U.S. NUCLEAR REGULATORY COMMISSION
OFFICE OF NUCLEAR MATERIAL SAFETY AND SAFEGUARDS
DIVISION OF FUEL CYCLE SAFETY, SAFEGUARDS, AND
ENVIRONMENTAL REVIEW

FINAL ENVIRONMENTAL ASSESSMENT FOR THE LUDEMAN
SATELLITE IN SITU RECOVERY PROJECT,
CONVERSE COUNTY, WYOMING

DOCKET NO. 40-8502

August 2018

Figure 2-1. Conceptual Site Layout of the Ludeman ISR Satellite Project (Uranium One, 2017e)

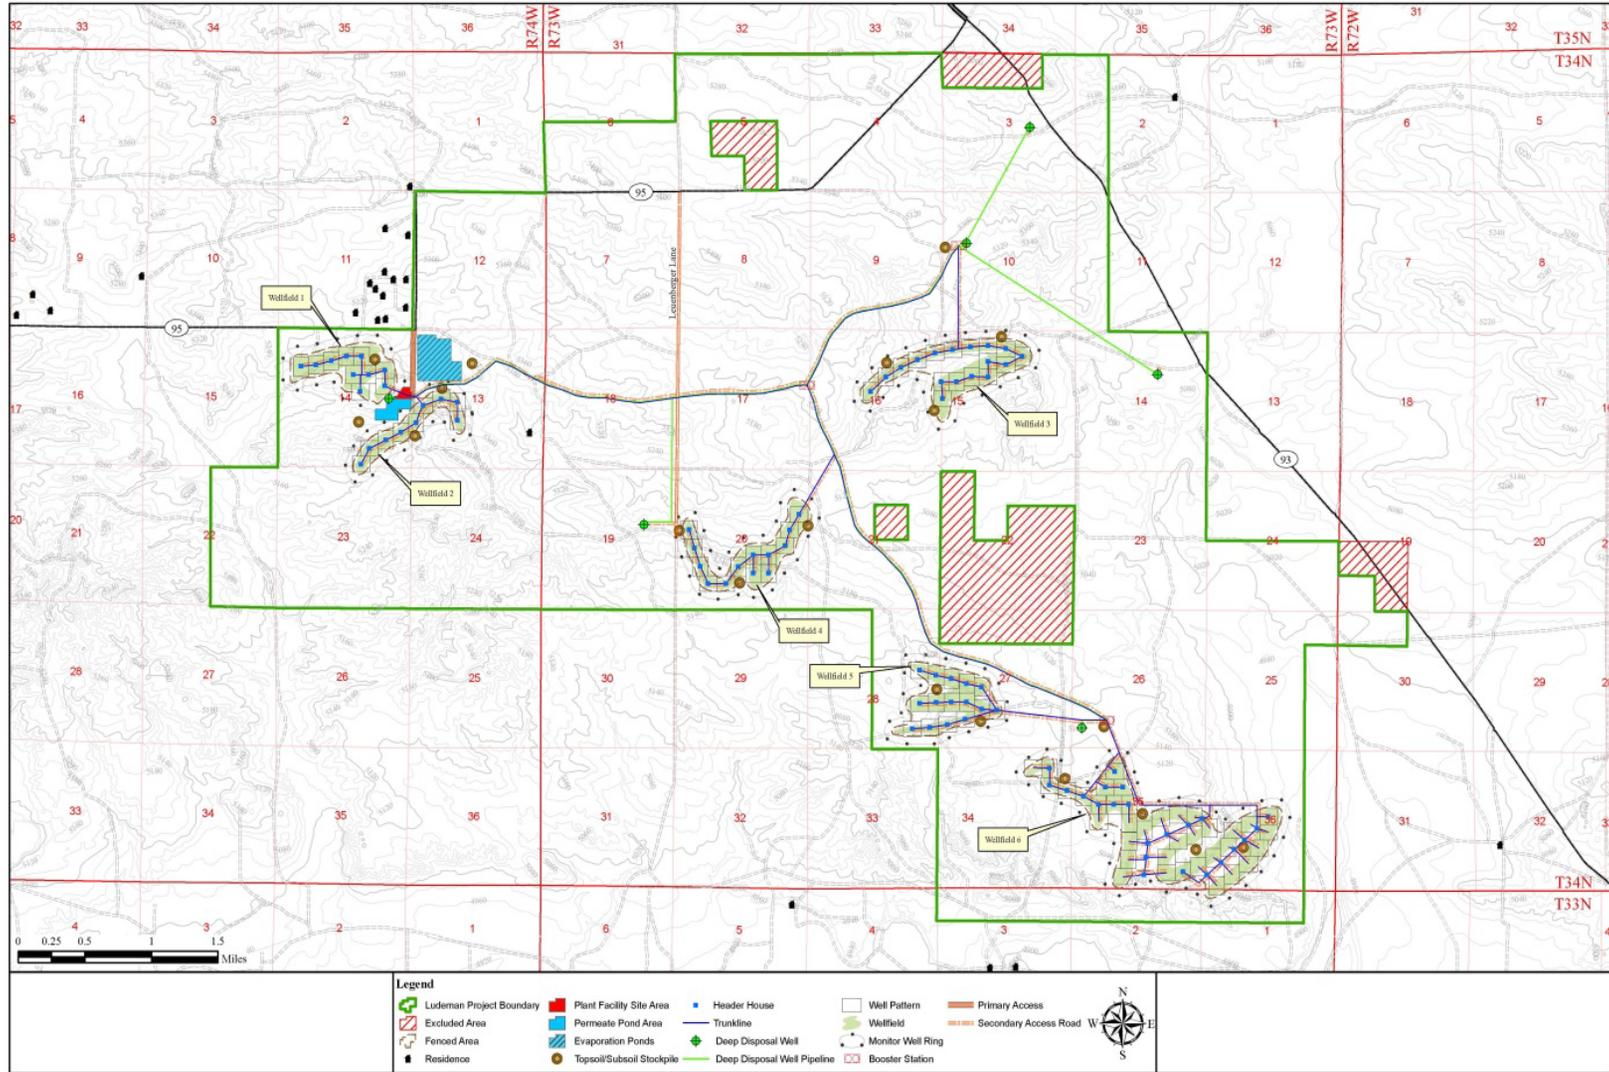
“Figure 2-1, Conceptual Site Layout of the Ludeman ISR Satellite Project, page 2-5. This map is very difficult to read due to the font size and very small features on the map. It is suggested that the map be revised to either enlarge the font or configure the map to be divided up into sections.”

Response: *The NRC acknowledges that EA Figure 2-1 is difficult to read because of the font size and very small features. Figure 2-1 was revised to enlarge the font size and resized to improve its readability.*

Figure 2-2. Proposed Project Schedule for Ludeman ISR Satellite Project (Uranium One, 2017e)

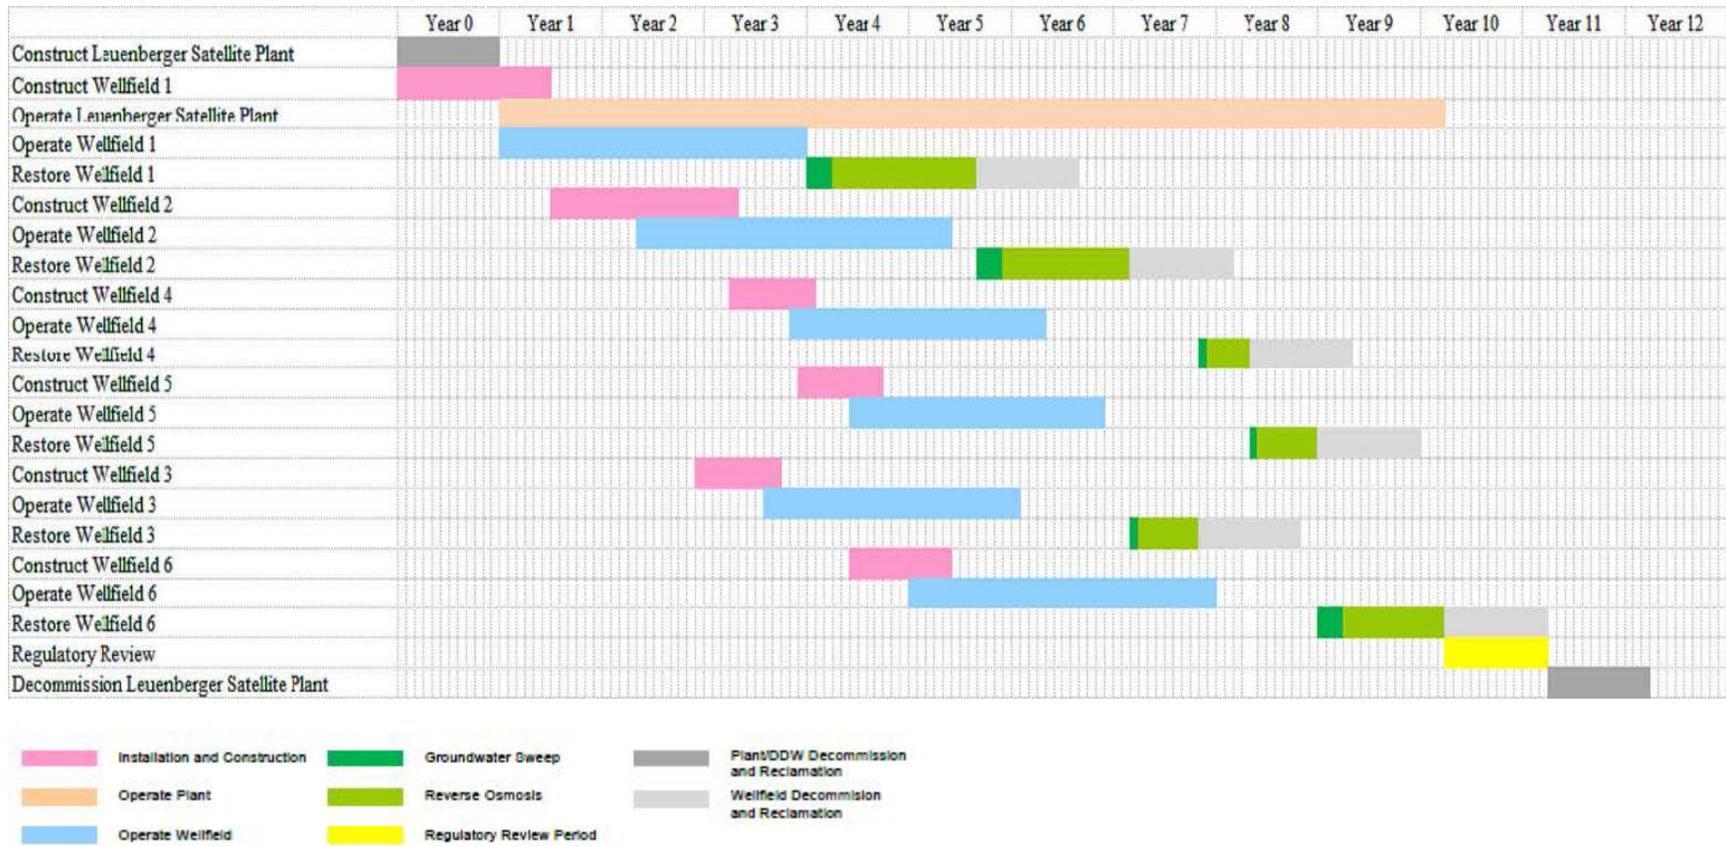
“Figure 2-2, Proposed Project Schedule for Ludeman ISR Satellite Project, page 2-6. As noted in Comment #6 above, the NRC has made a determination that Wellfield 2 will not be

Figure 3-2. Watersheds and Surface Water Features in the Proposed Ludeman ISR Project Area and 3.2-km [2-mi] Buffer (Modified from Uranium One, 2017d)

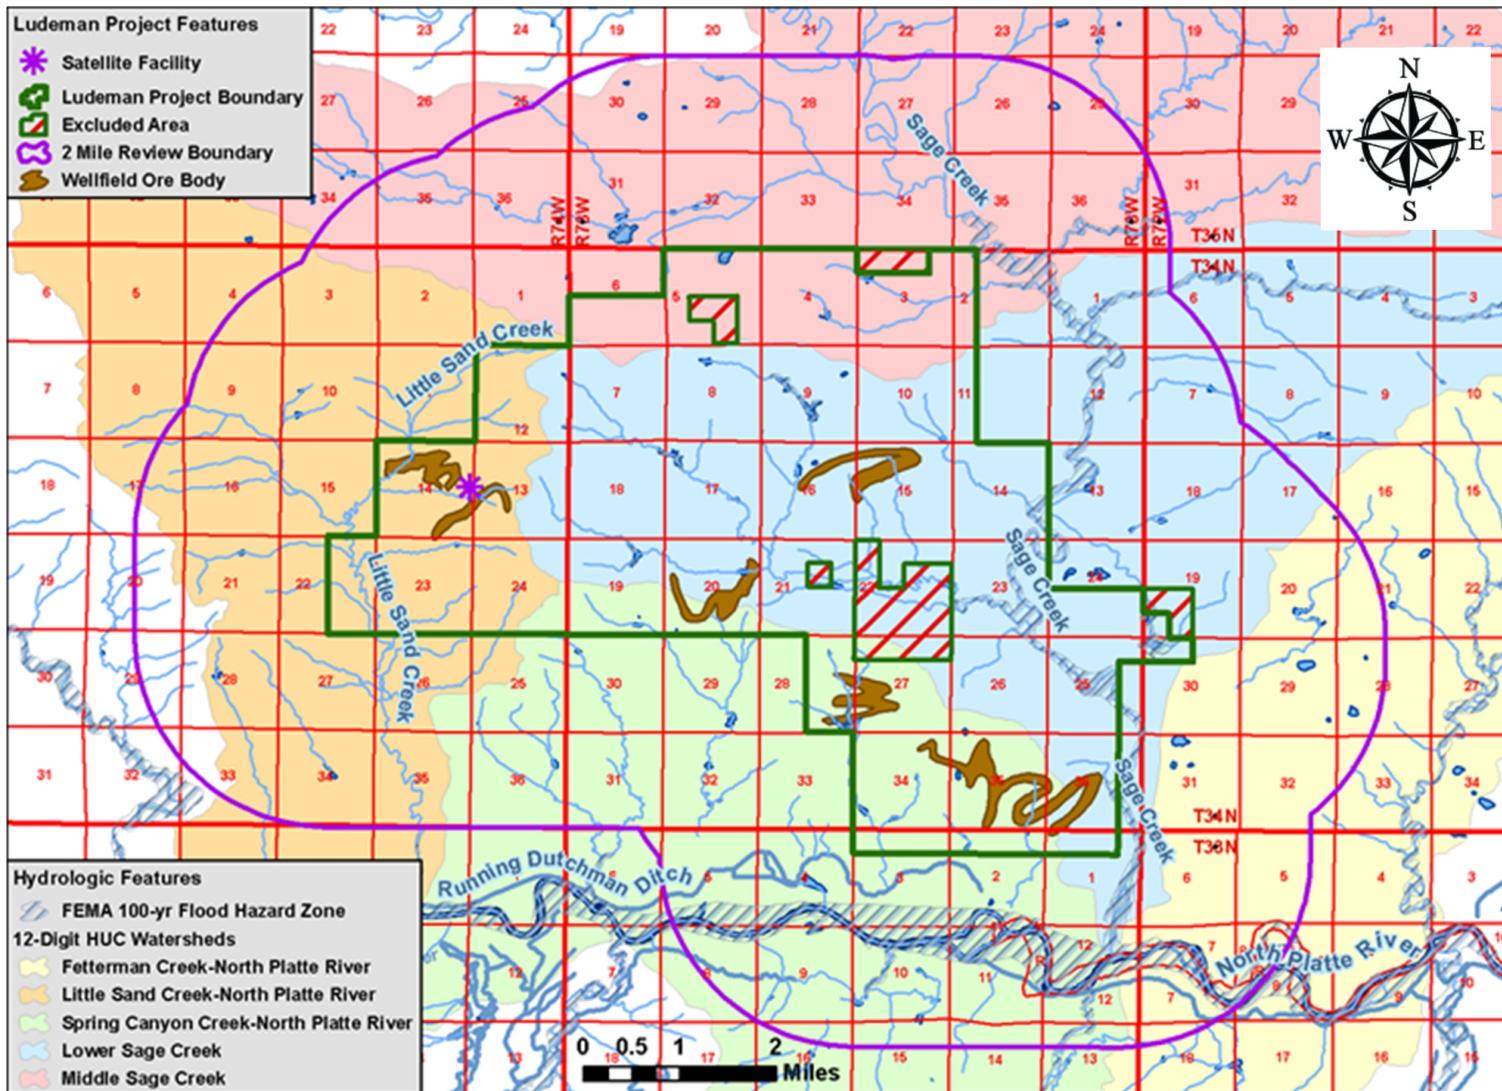
"Figure 3-2, Watersheds and Surface Water Features in the Proposed Ludeman ISR Project Area and 3.2 km (2 mi) Buffer, page 3-14. This map does not have a north arrow and should be added to the figure."

Response: *The NRC agrees with the comment. A north arrow was added to EA Figure 3-2.*

Figure 3-3. Subwatersheds, Surface Water Features, FEMA 100-year Flood Hazard Zones, Surface Water Rights and Sampling Locations at the Proposed Ludeman ISR Project (Modified from Uranium One, 2017d).

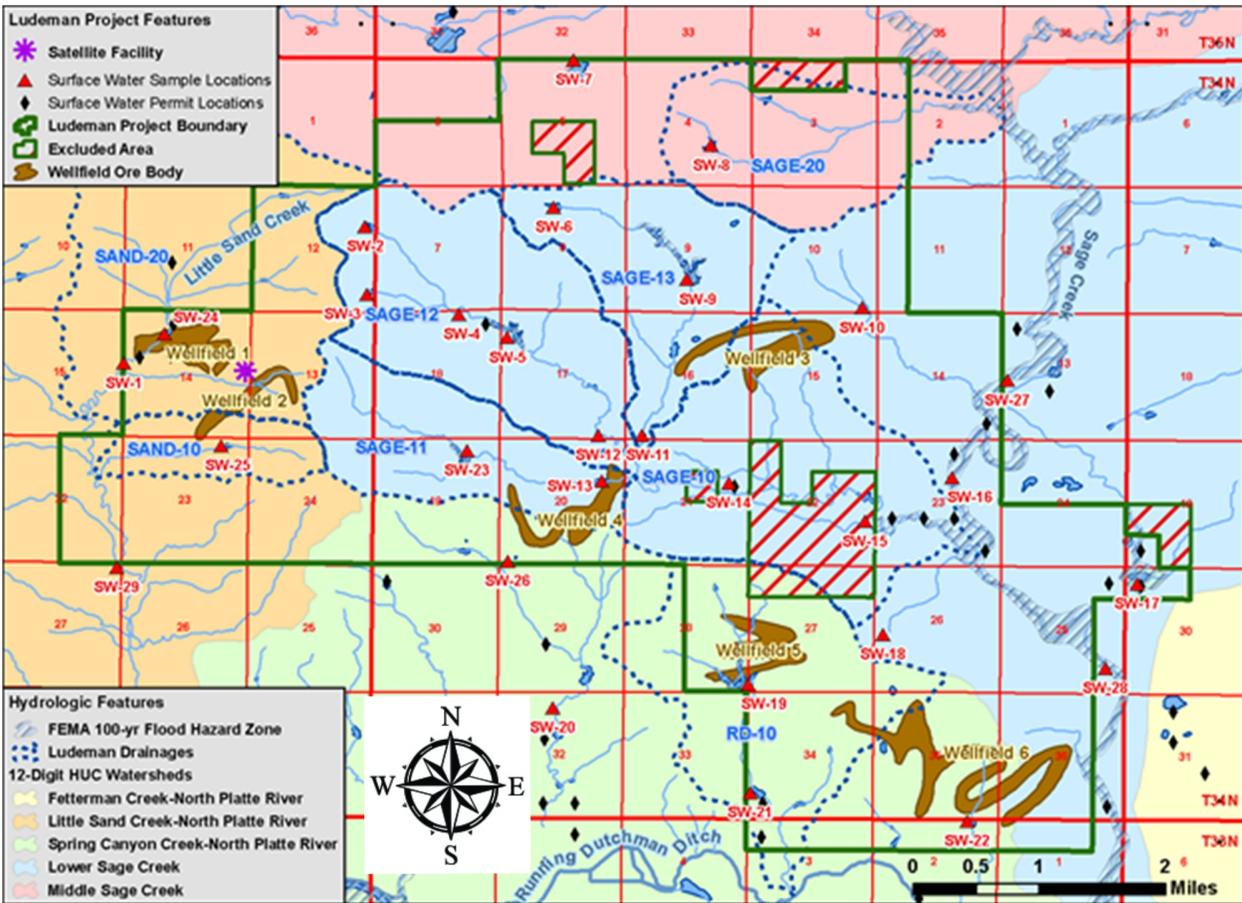
"Figure 3-3, Subwatersheds, Surface Water Features, FEMA 100-year Flood Hazard Zones, Surface Water Rights and Sampling Locations at the Proposed Ludeman ISR Project, page 3-16. This map does not have a north arrow and should be added to the figure."

Response: *The NRC agrees with the comment. A north arrow was added to EA Figure 3-3.*
